This Service Manual Supplement is a Supplement to Service Manual, 820-500"Hood VHD"

Hood Modification

Headlamp Assembly, Replacement VHD

3521-03-02-01 Headlamp Assembly, Replacement

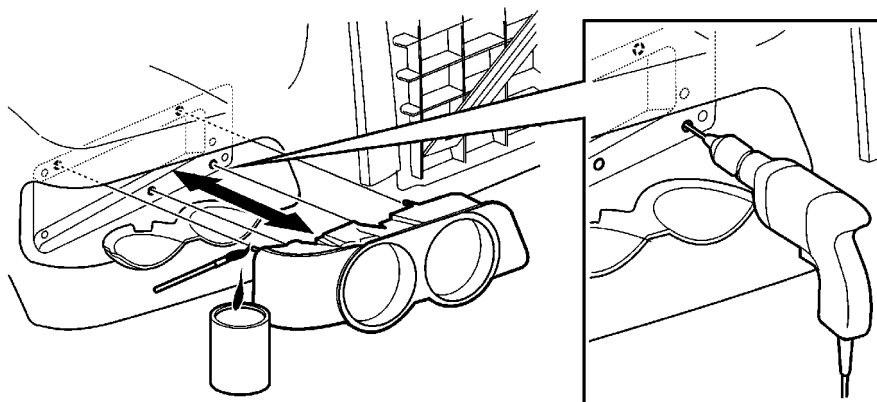
Modification of the VHD hood is necessary when installing a new headlamp assembly due to a new design. Follow the instructions on the next page to install the new headlamp assembly:

W3005036

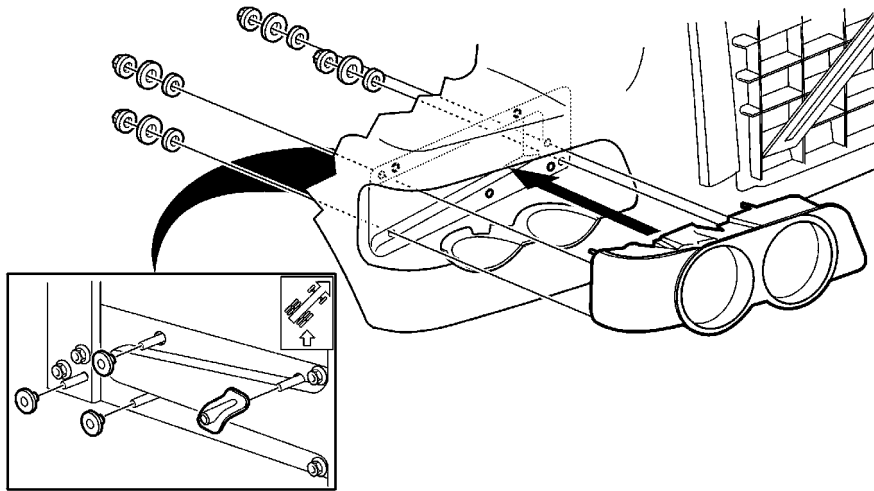
Mark the holes by placing a small amount of paint at the end of each adjusting stud. Before the paint dries, set the headlamp assembly into position. When pulled out the paint marks will show points where the holes should be drilled.

Use a drill and a 12.7 mm (1/2 in.) hole saw to drill the holes.
